PREPARED FOR THE URBAN DESIGN COMMISSION AND PLAN COMMISSION

Project Address: 626 Langdon Street
Application Type: Conditional Use
Legistar File ID # [33685](#)
Prepared By: Heather Stouder, AICP, Planning Division
Reviewed By: Katherine Cornwell, AICP, Planning Division Director
Report Includes Comments from other City Agencies, as noted

Requested Action: The applicant requests conditional use approval for construction of an eight-story addition to the Roundhouse apartment building in the DR2 (Downtown Residential 2) District. Conditional use review is required for a multi-family building with over eight residential units.

Figure 1

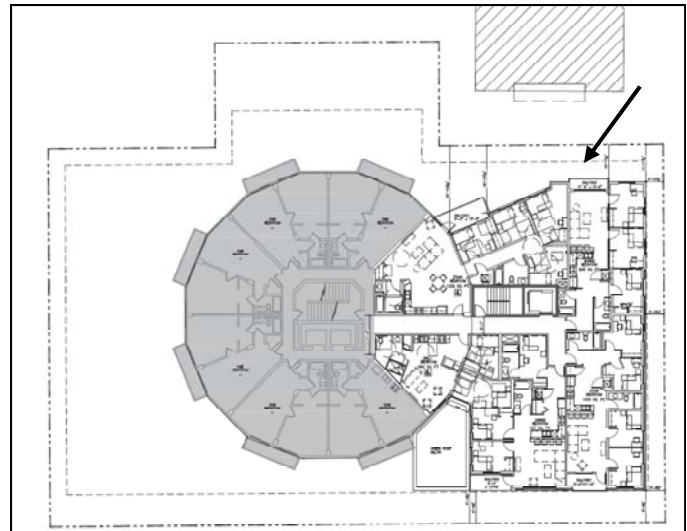
The applicant has successfully distinguished the proposed addition from the Roundhouse, so that it reads as a separate building from some angles, but along Langdon Street, its width of nearly 140 feet is triple or quadruple the width of all other buildings in the area north of Langdon Street, and is also greater than the street width of Langdon Hall and the Hillel building across the street to the south. The DR2 Zoning District does not have a building width limitation. However, the Plan Commission should take into account the difference in scale (and shape) between the resulting proposed building and others in the area, and should consider how well it fits in to the Langdon National Register Historic District.

Access, Parking, and Circulation - Pedestrian access to the new central lobby area represents a significant improvement to the existing condition. However, access to the bicycle and moped parking areas for residents is indirect, with both needing to travel over 200 feet from the street around the back of the building to the entrance to each respective area. Moped riders would dismount at the back of the building and walk the moped to a stall along the eastern edge of the building, parking in an area protected from weather by the cantilevered building above. Bicyclists would enter the rear of the building and head down a stairway to a basement parking area. If this project were to be approved, staff recommends that the stairway leading down to the bicycle parking area have a ramp incorporated for convenience in walking a bicycle down these stairs.
